Access Compliance Report

Public Rights-of-Way

(Curb Ramps)

Intersection ID: 49927	Main Street: ASHBOURNE_HALL_RD	Cross Street: CAMPBELL_HALL_CT	Location: NW
ADA ID: F6810F6999E2	Ramp Type: Perp	Initial Pass/Fail: Fail	Overall Compliance: No
Severity Score: 12.5			
Codes/Mitigation Info/Possible Solution		Field Measurements/Component Compliance

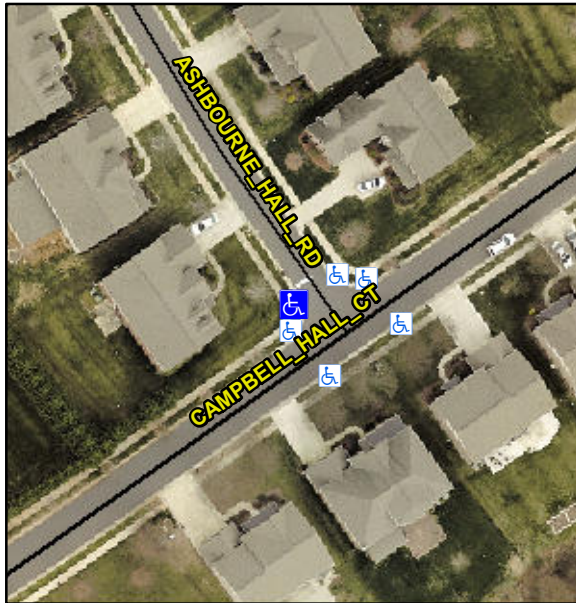
Not Found, R304.2.2

Compliance	Description	Data	Compliance	Description	Data
N/A	Ramp Length (in)	47.0	No	Ramp Slope (%)	10.7
Yes	Ramp Width (in)	48.0	Yes	Ramp XSlope (%)	0.5
N/A	Flare Type LT	N/A	N/A	Flare Type RT	N/A
N/A	Flare Slope LT (%)	N/A	N/A	Flare Slope RT (%)	N/A
N/A	Flare Traversable LT?	N/A	N/A	Flare Traversable RT?	N/A
N/A	Landing Length (in)	N/A	N/A	DWS Provided?	N/A
N/A	Landing Width (in)	N/A	N/A	DWS Contrast?	N/A
N/A	Landing Slope (%)	N/A	N/A	DWS Length (in)	N/A
N/A	Landing X Slope (%)	N/A	N/A	DWS Full Width?	N/A
N/A	Landing Curb? (Y/N)	N/A	N/A	DWS Offset (in)	N/A
N/A	Shared Landing?	N/A			
N/A	Gutter Ponding?	N/A	N/A	Gutter Slope (%)	N/A
N/A	Gutter Lip Ht (in)	N/A	N/A	Gutter X Slope (%)	N/A
N/A	Painted X Walk1?	No	N/A	Painted X Walk2?	N/A
	X Walk 1 Direction	To NE		X Walk 2 Direction	N/A
N/A	X Walk 1 Width (in)	N/A	N/A	X Walk 2 Width (in)	N/A
	X Walk 1 Slope (%)	1.2		X Walk 2 Slope (%)	N/A
	X Walk 1 X Slope (%)	2.0		X Walk 2 X Slope (%)	N/A

Remove & Replace Entire Ramp.
